Application for Works Approval

Works Approval Number	W3044/2025/1
Applicant	Yindjibarndi Energy Corporation Pty Ltd
ACN	667 821 865
File number	APP-0029166
Premises	Jinbi Solar Facility Legal description Unallocated Crown Land PIN 1017635 and 1017648 As defined by the premises maps attached to the issued works approval
Date of report	13 January 2026
Decision	Works approval granted

Appendix 1: Summary of applicant's comments on risk assessment and draft conditions

Figure 1: Layout of WWTP – camp and irrigation areas

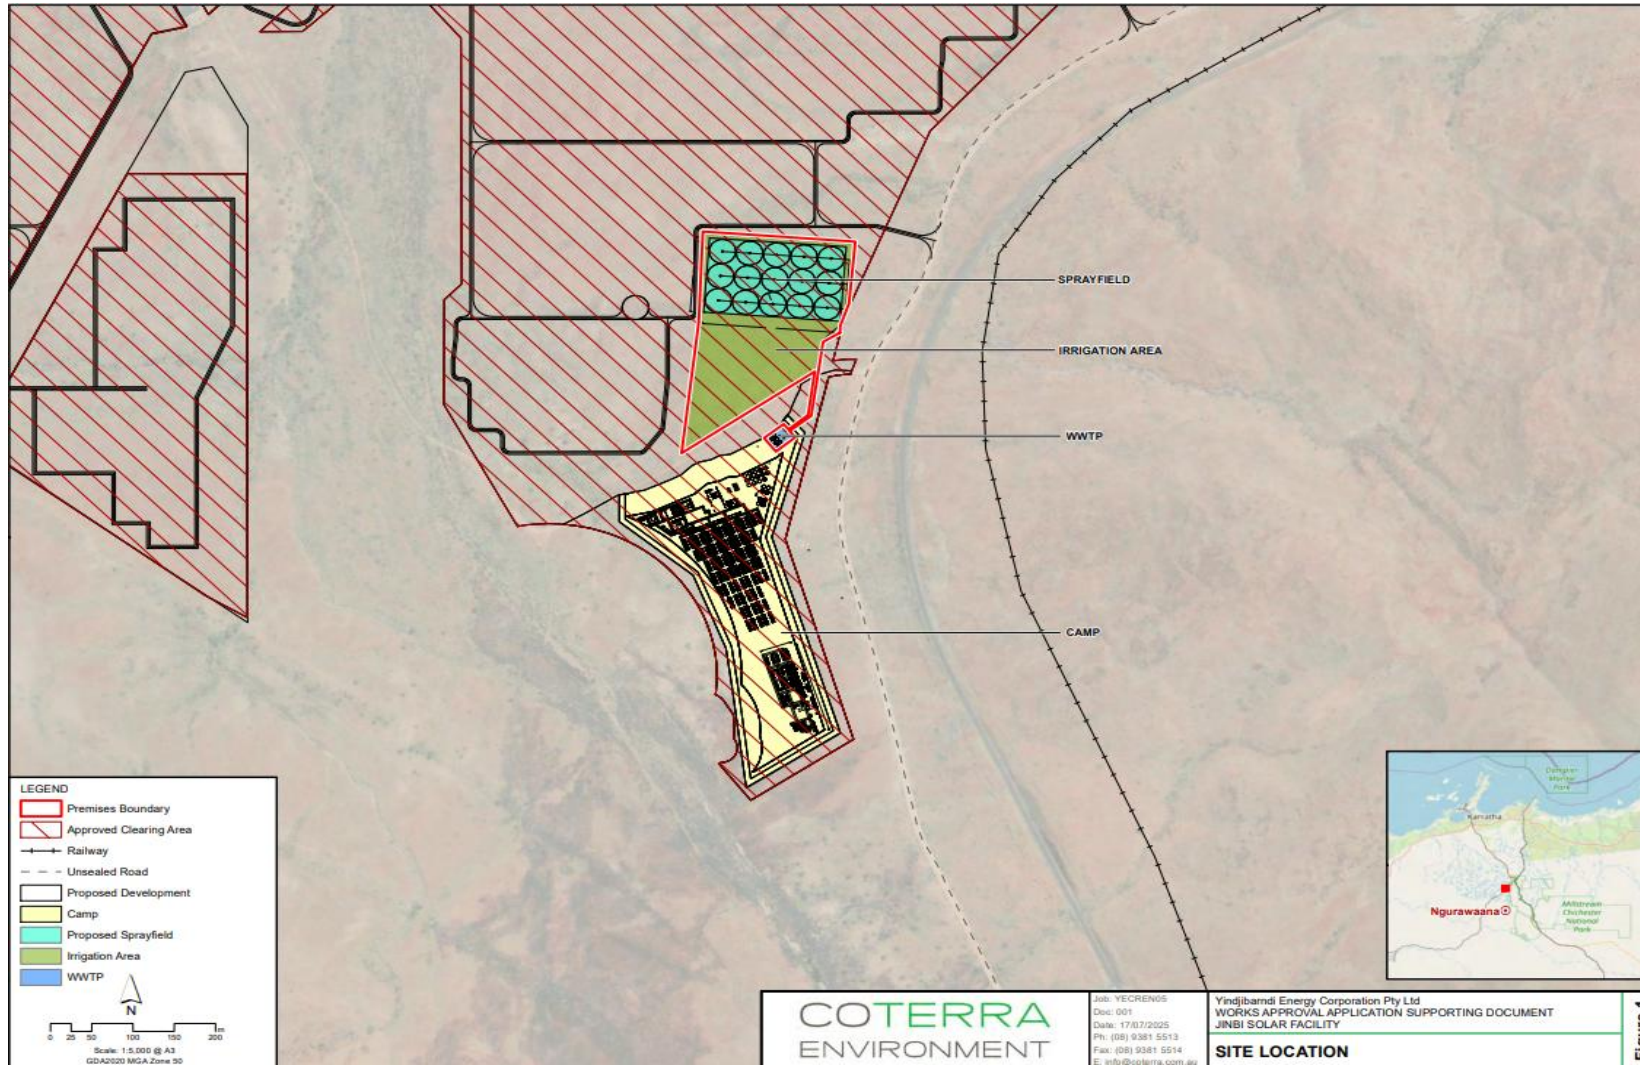
Treated wastewater, as outlined in Table 1, will be discharged to a designated spray field. The applicant proposes an irrigation spray field of 1.6 ha, with an additional contingency irrigation area of 3.7 ha available as the WWTP approaches its maximum capacity. Treated wastewater will be transferred to the irrigation spray field via above-ground poly piping; where the pipeline crosses access tracks, it will be below ground. The spray field will comprise of a series of impulse sprinklers arranged evenly across the irrigation area (see Figure 1 for the indicative WWTP layout).

When compared to WQPN 22 criteria, discharging 68 m³ per day of treated effluent (as per Table 1) to the proposed 1.4 ha irrigation area would significantly exceed these limits:

- Nitrogen: 775.6 kg/ha/year
- Phosphorus: 186.2 kg/ha/yr.

Condition	Summary of applicant's comment	Department's response
Condition 1 Table 1 Applicant please advise volume or number of days contingency	<p>An amended layout has been provided with this response which includes an additional 50kL Emergency Storage Tank, providing 40kL capacity. This combined with the two balance tanks will provide 145kL (2.7 days) of contingency storage capacity.</p> <p>For cyclonic events, YEC will implement all actions recommended by the Department of Fire and Emergency Services, which may include 'locking and leaving' the Jinbi construction camp. There will be no effluent generation if the camp is evacuated in this manner.</p>	The department needs further clarity on the make-up storage capacity. If it is intended that the plant will be switched off during an emergency, please provide details of the start up procedure to meet treatment criteria prior to discharge.
Condition 1 Table 1 Applicant please advise overflow and active alarm procedure	Contingency and emergency procedures for the plant's operation, including in the event of alarm activations, are detailed in dedicated document submitted with this response.	The department requires emergency procedures that provide clear outcomes. For example, where effluent quality does not meet criteria, it is not clear how this is rectified or if the waste is recirculated back through the system for further treatment,

Condition 1 Table 1 Applicant please advise sludge management	A dedicated process flow diagram has been provided with this response and has been illustrated on the amended layout.	The department requires additional details of the flow of the treatment plant. This could include a schematic plan of the WWTP system to illustrate the location of the screen and the movement of sludge to the upstream balance tank.
Condition 16 Table 6 Applicant to advise on sludge storage location

However, if the contingency irrigation area of 3.7 ha is utilised, the nutrient loading rates would be reduced to:

- Nitrogen: 335.4 kg/ha/yr
- Phosphorus: 80.5 kg/ha/yr

Condition	Summary of applicant's comment	Department's response
Condition 1 Table 1 Applicant please advise volume or	Approximately 140 to 145m ³ of storage and buffer capacity is made up of the emergency tank and additional storage buffer in the Balance and effluent tanks. The design of the plant allows for process updates	Noted the works approval has been updated.
